Access Compliance Report

Public Rights-of-Way

(Curb Ramps)

Intersection ID: 16112	Main Street: ANSON_ST	Cross Street: HARTFORD_AV	Location: E
ADA ID: 52B4B5B30FA3	Ramp Type: PerpDiag	Initial Pass/Fail: Fail	Overall Compliance: No
Severity Score: 1.25			
Codes/Mitigation Info/Possible Solution		Field Measurements/Component Compliance

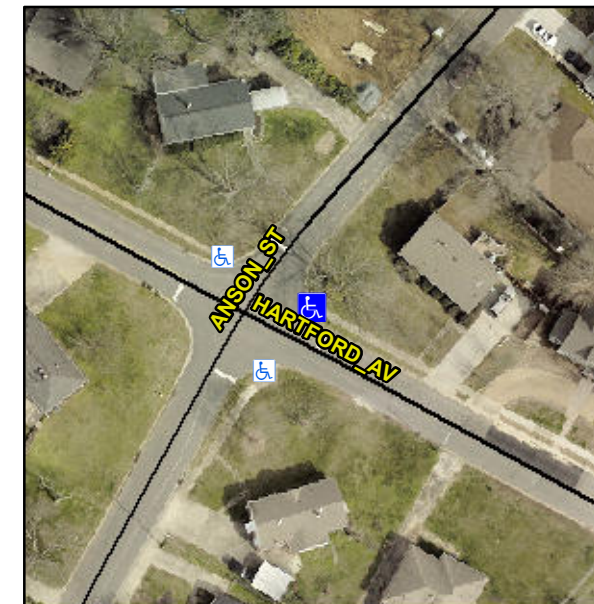
Not Found, R304.5.3

Compliance	Description	Data	Compliance	Description	Data
N/A	Ramp Length (in)	59.0	Yes	Ramp Slope (%)	5.6
Yes	Ramp Width (in)	48.0	No	Ramp XSlope (%)	3.2
N/A	Flare Type LT	N/A	N/A	Flare Type RT	N/A
N/A	Flare Slope LT (%)	N/A	N/A	Flare Slope RT (%)	N/A
N/A	Flare Traversable LT?	N/A	N/A	Flare Traversable RT?	N/A
N/A	Landing Length (in)	N/A	N/A	DWS Provided?	N/A
N/A	Landing Width (in)	N/A	N/A	DWS Contrast?	N/A
N/A	Landing Slope (%)	N/A	N/A	DWS Length (in)	N/A
N/A	Landing X Slope (%)	N/A	N/A	DWS Full Width?	N/A
N/A	Landing Curb? (Y/N)	N/A	N/A	DWS Offset (in)	N/A
N/A	Shared Landing?	N/A			
N/A	Gutter Ponding?	N/A	N/A	Gutter Slope (%)	N/A
N/A	Gutter Lip Ht (in)	N/A	N/A	Gutter X Slope (%)	N/A
N/A	Painted X Walk1?	No	N/A	Painted X Walk2?	No
	X Walk 1 Direction	To NW		X Walk 2 Direction	To SW
N/A	X Walk 1 Width (in)	N/A	N/A	X Walk 2 Width (in)	N/A
	X Walk 1 Slope (%)	6.6		X Walk 2 Slope (%)	4.0
	X Walk 1 X Slope (%)	4.4		X Walk 2 X Slope (%)	4.4

N/A	Ramp inside XWalk1?	N/A	N/A	Ramp inside XWalk2?	N/A
	Road Slope (%)	0.7	N/A	Clear Space?	N/A
	Road X Slope (%)	7.5	N/A	Clear Space to XWalk (in)	N/A
N/A	Any Obstructions?	N/A	N/A	Storm Grate/Utility Hazard?	N/A
	Obstruction Type			Storm Grate/Utility Type	
		N/A			N/A
		Yes		Surface Condition? (G/P)	Good

Remove & Replace Curb Ramp With Two New Directional Ramps or Equivalent.
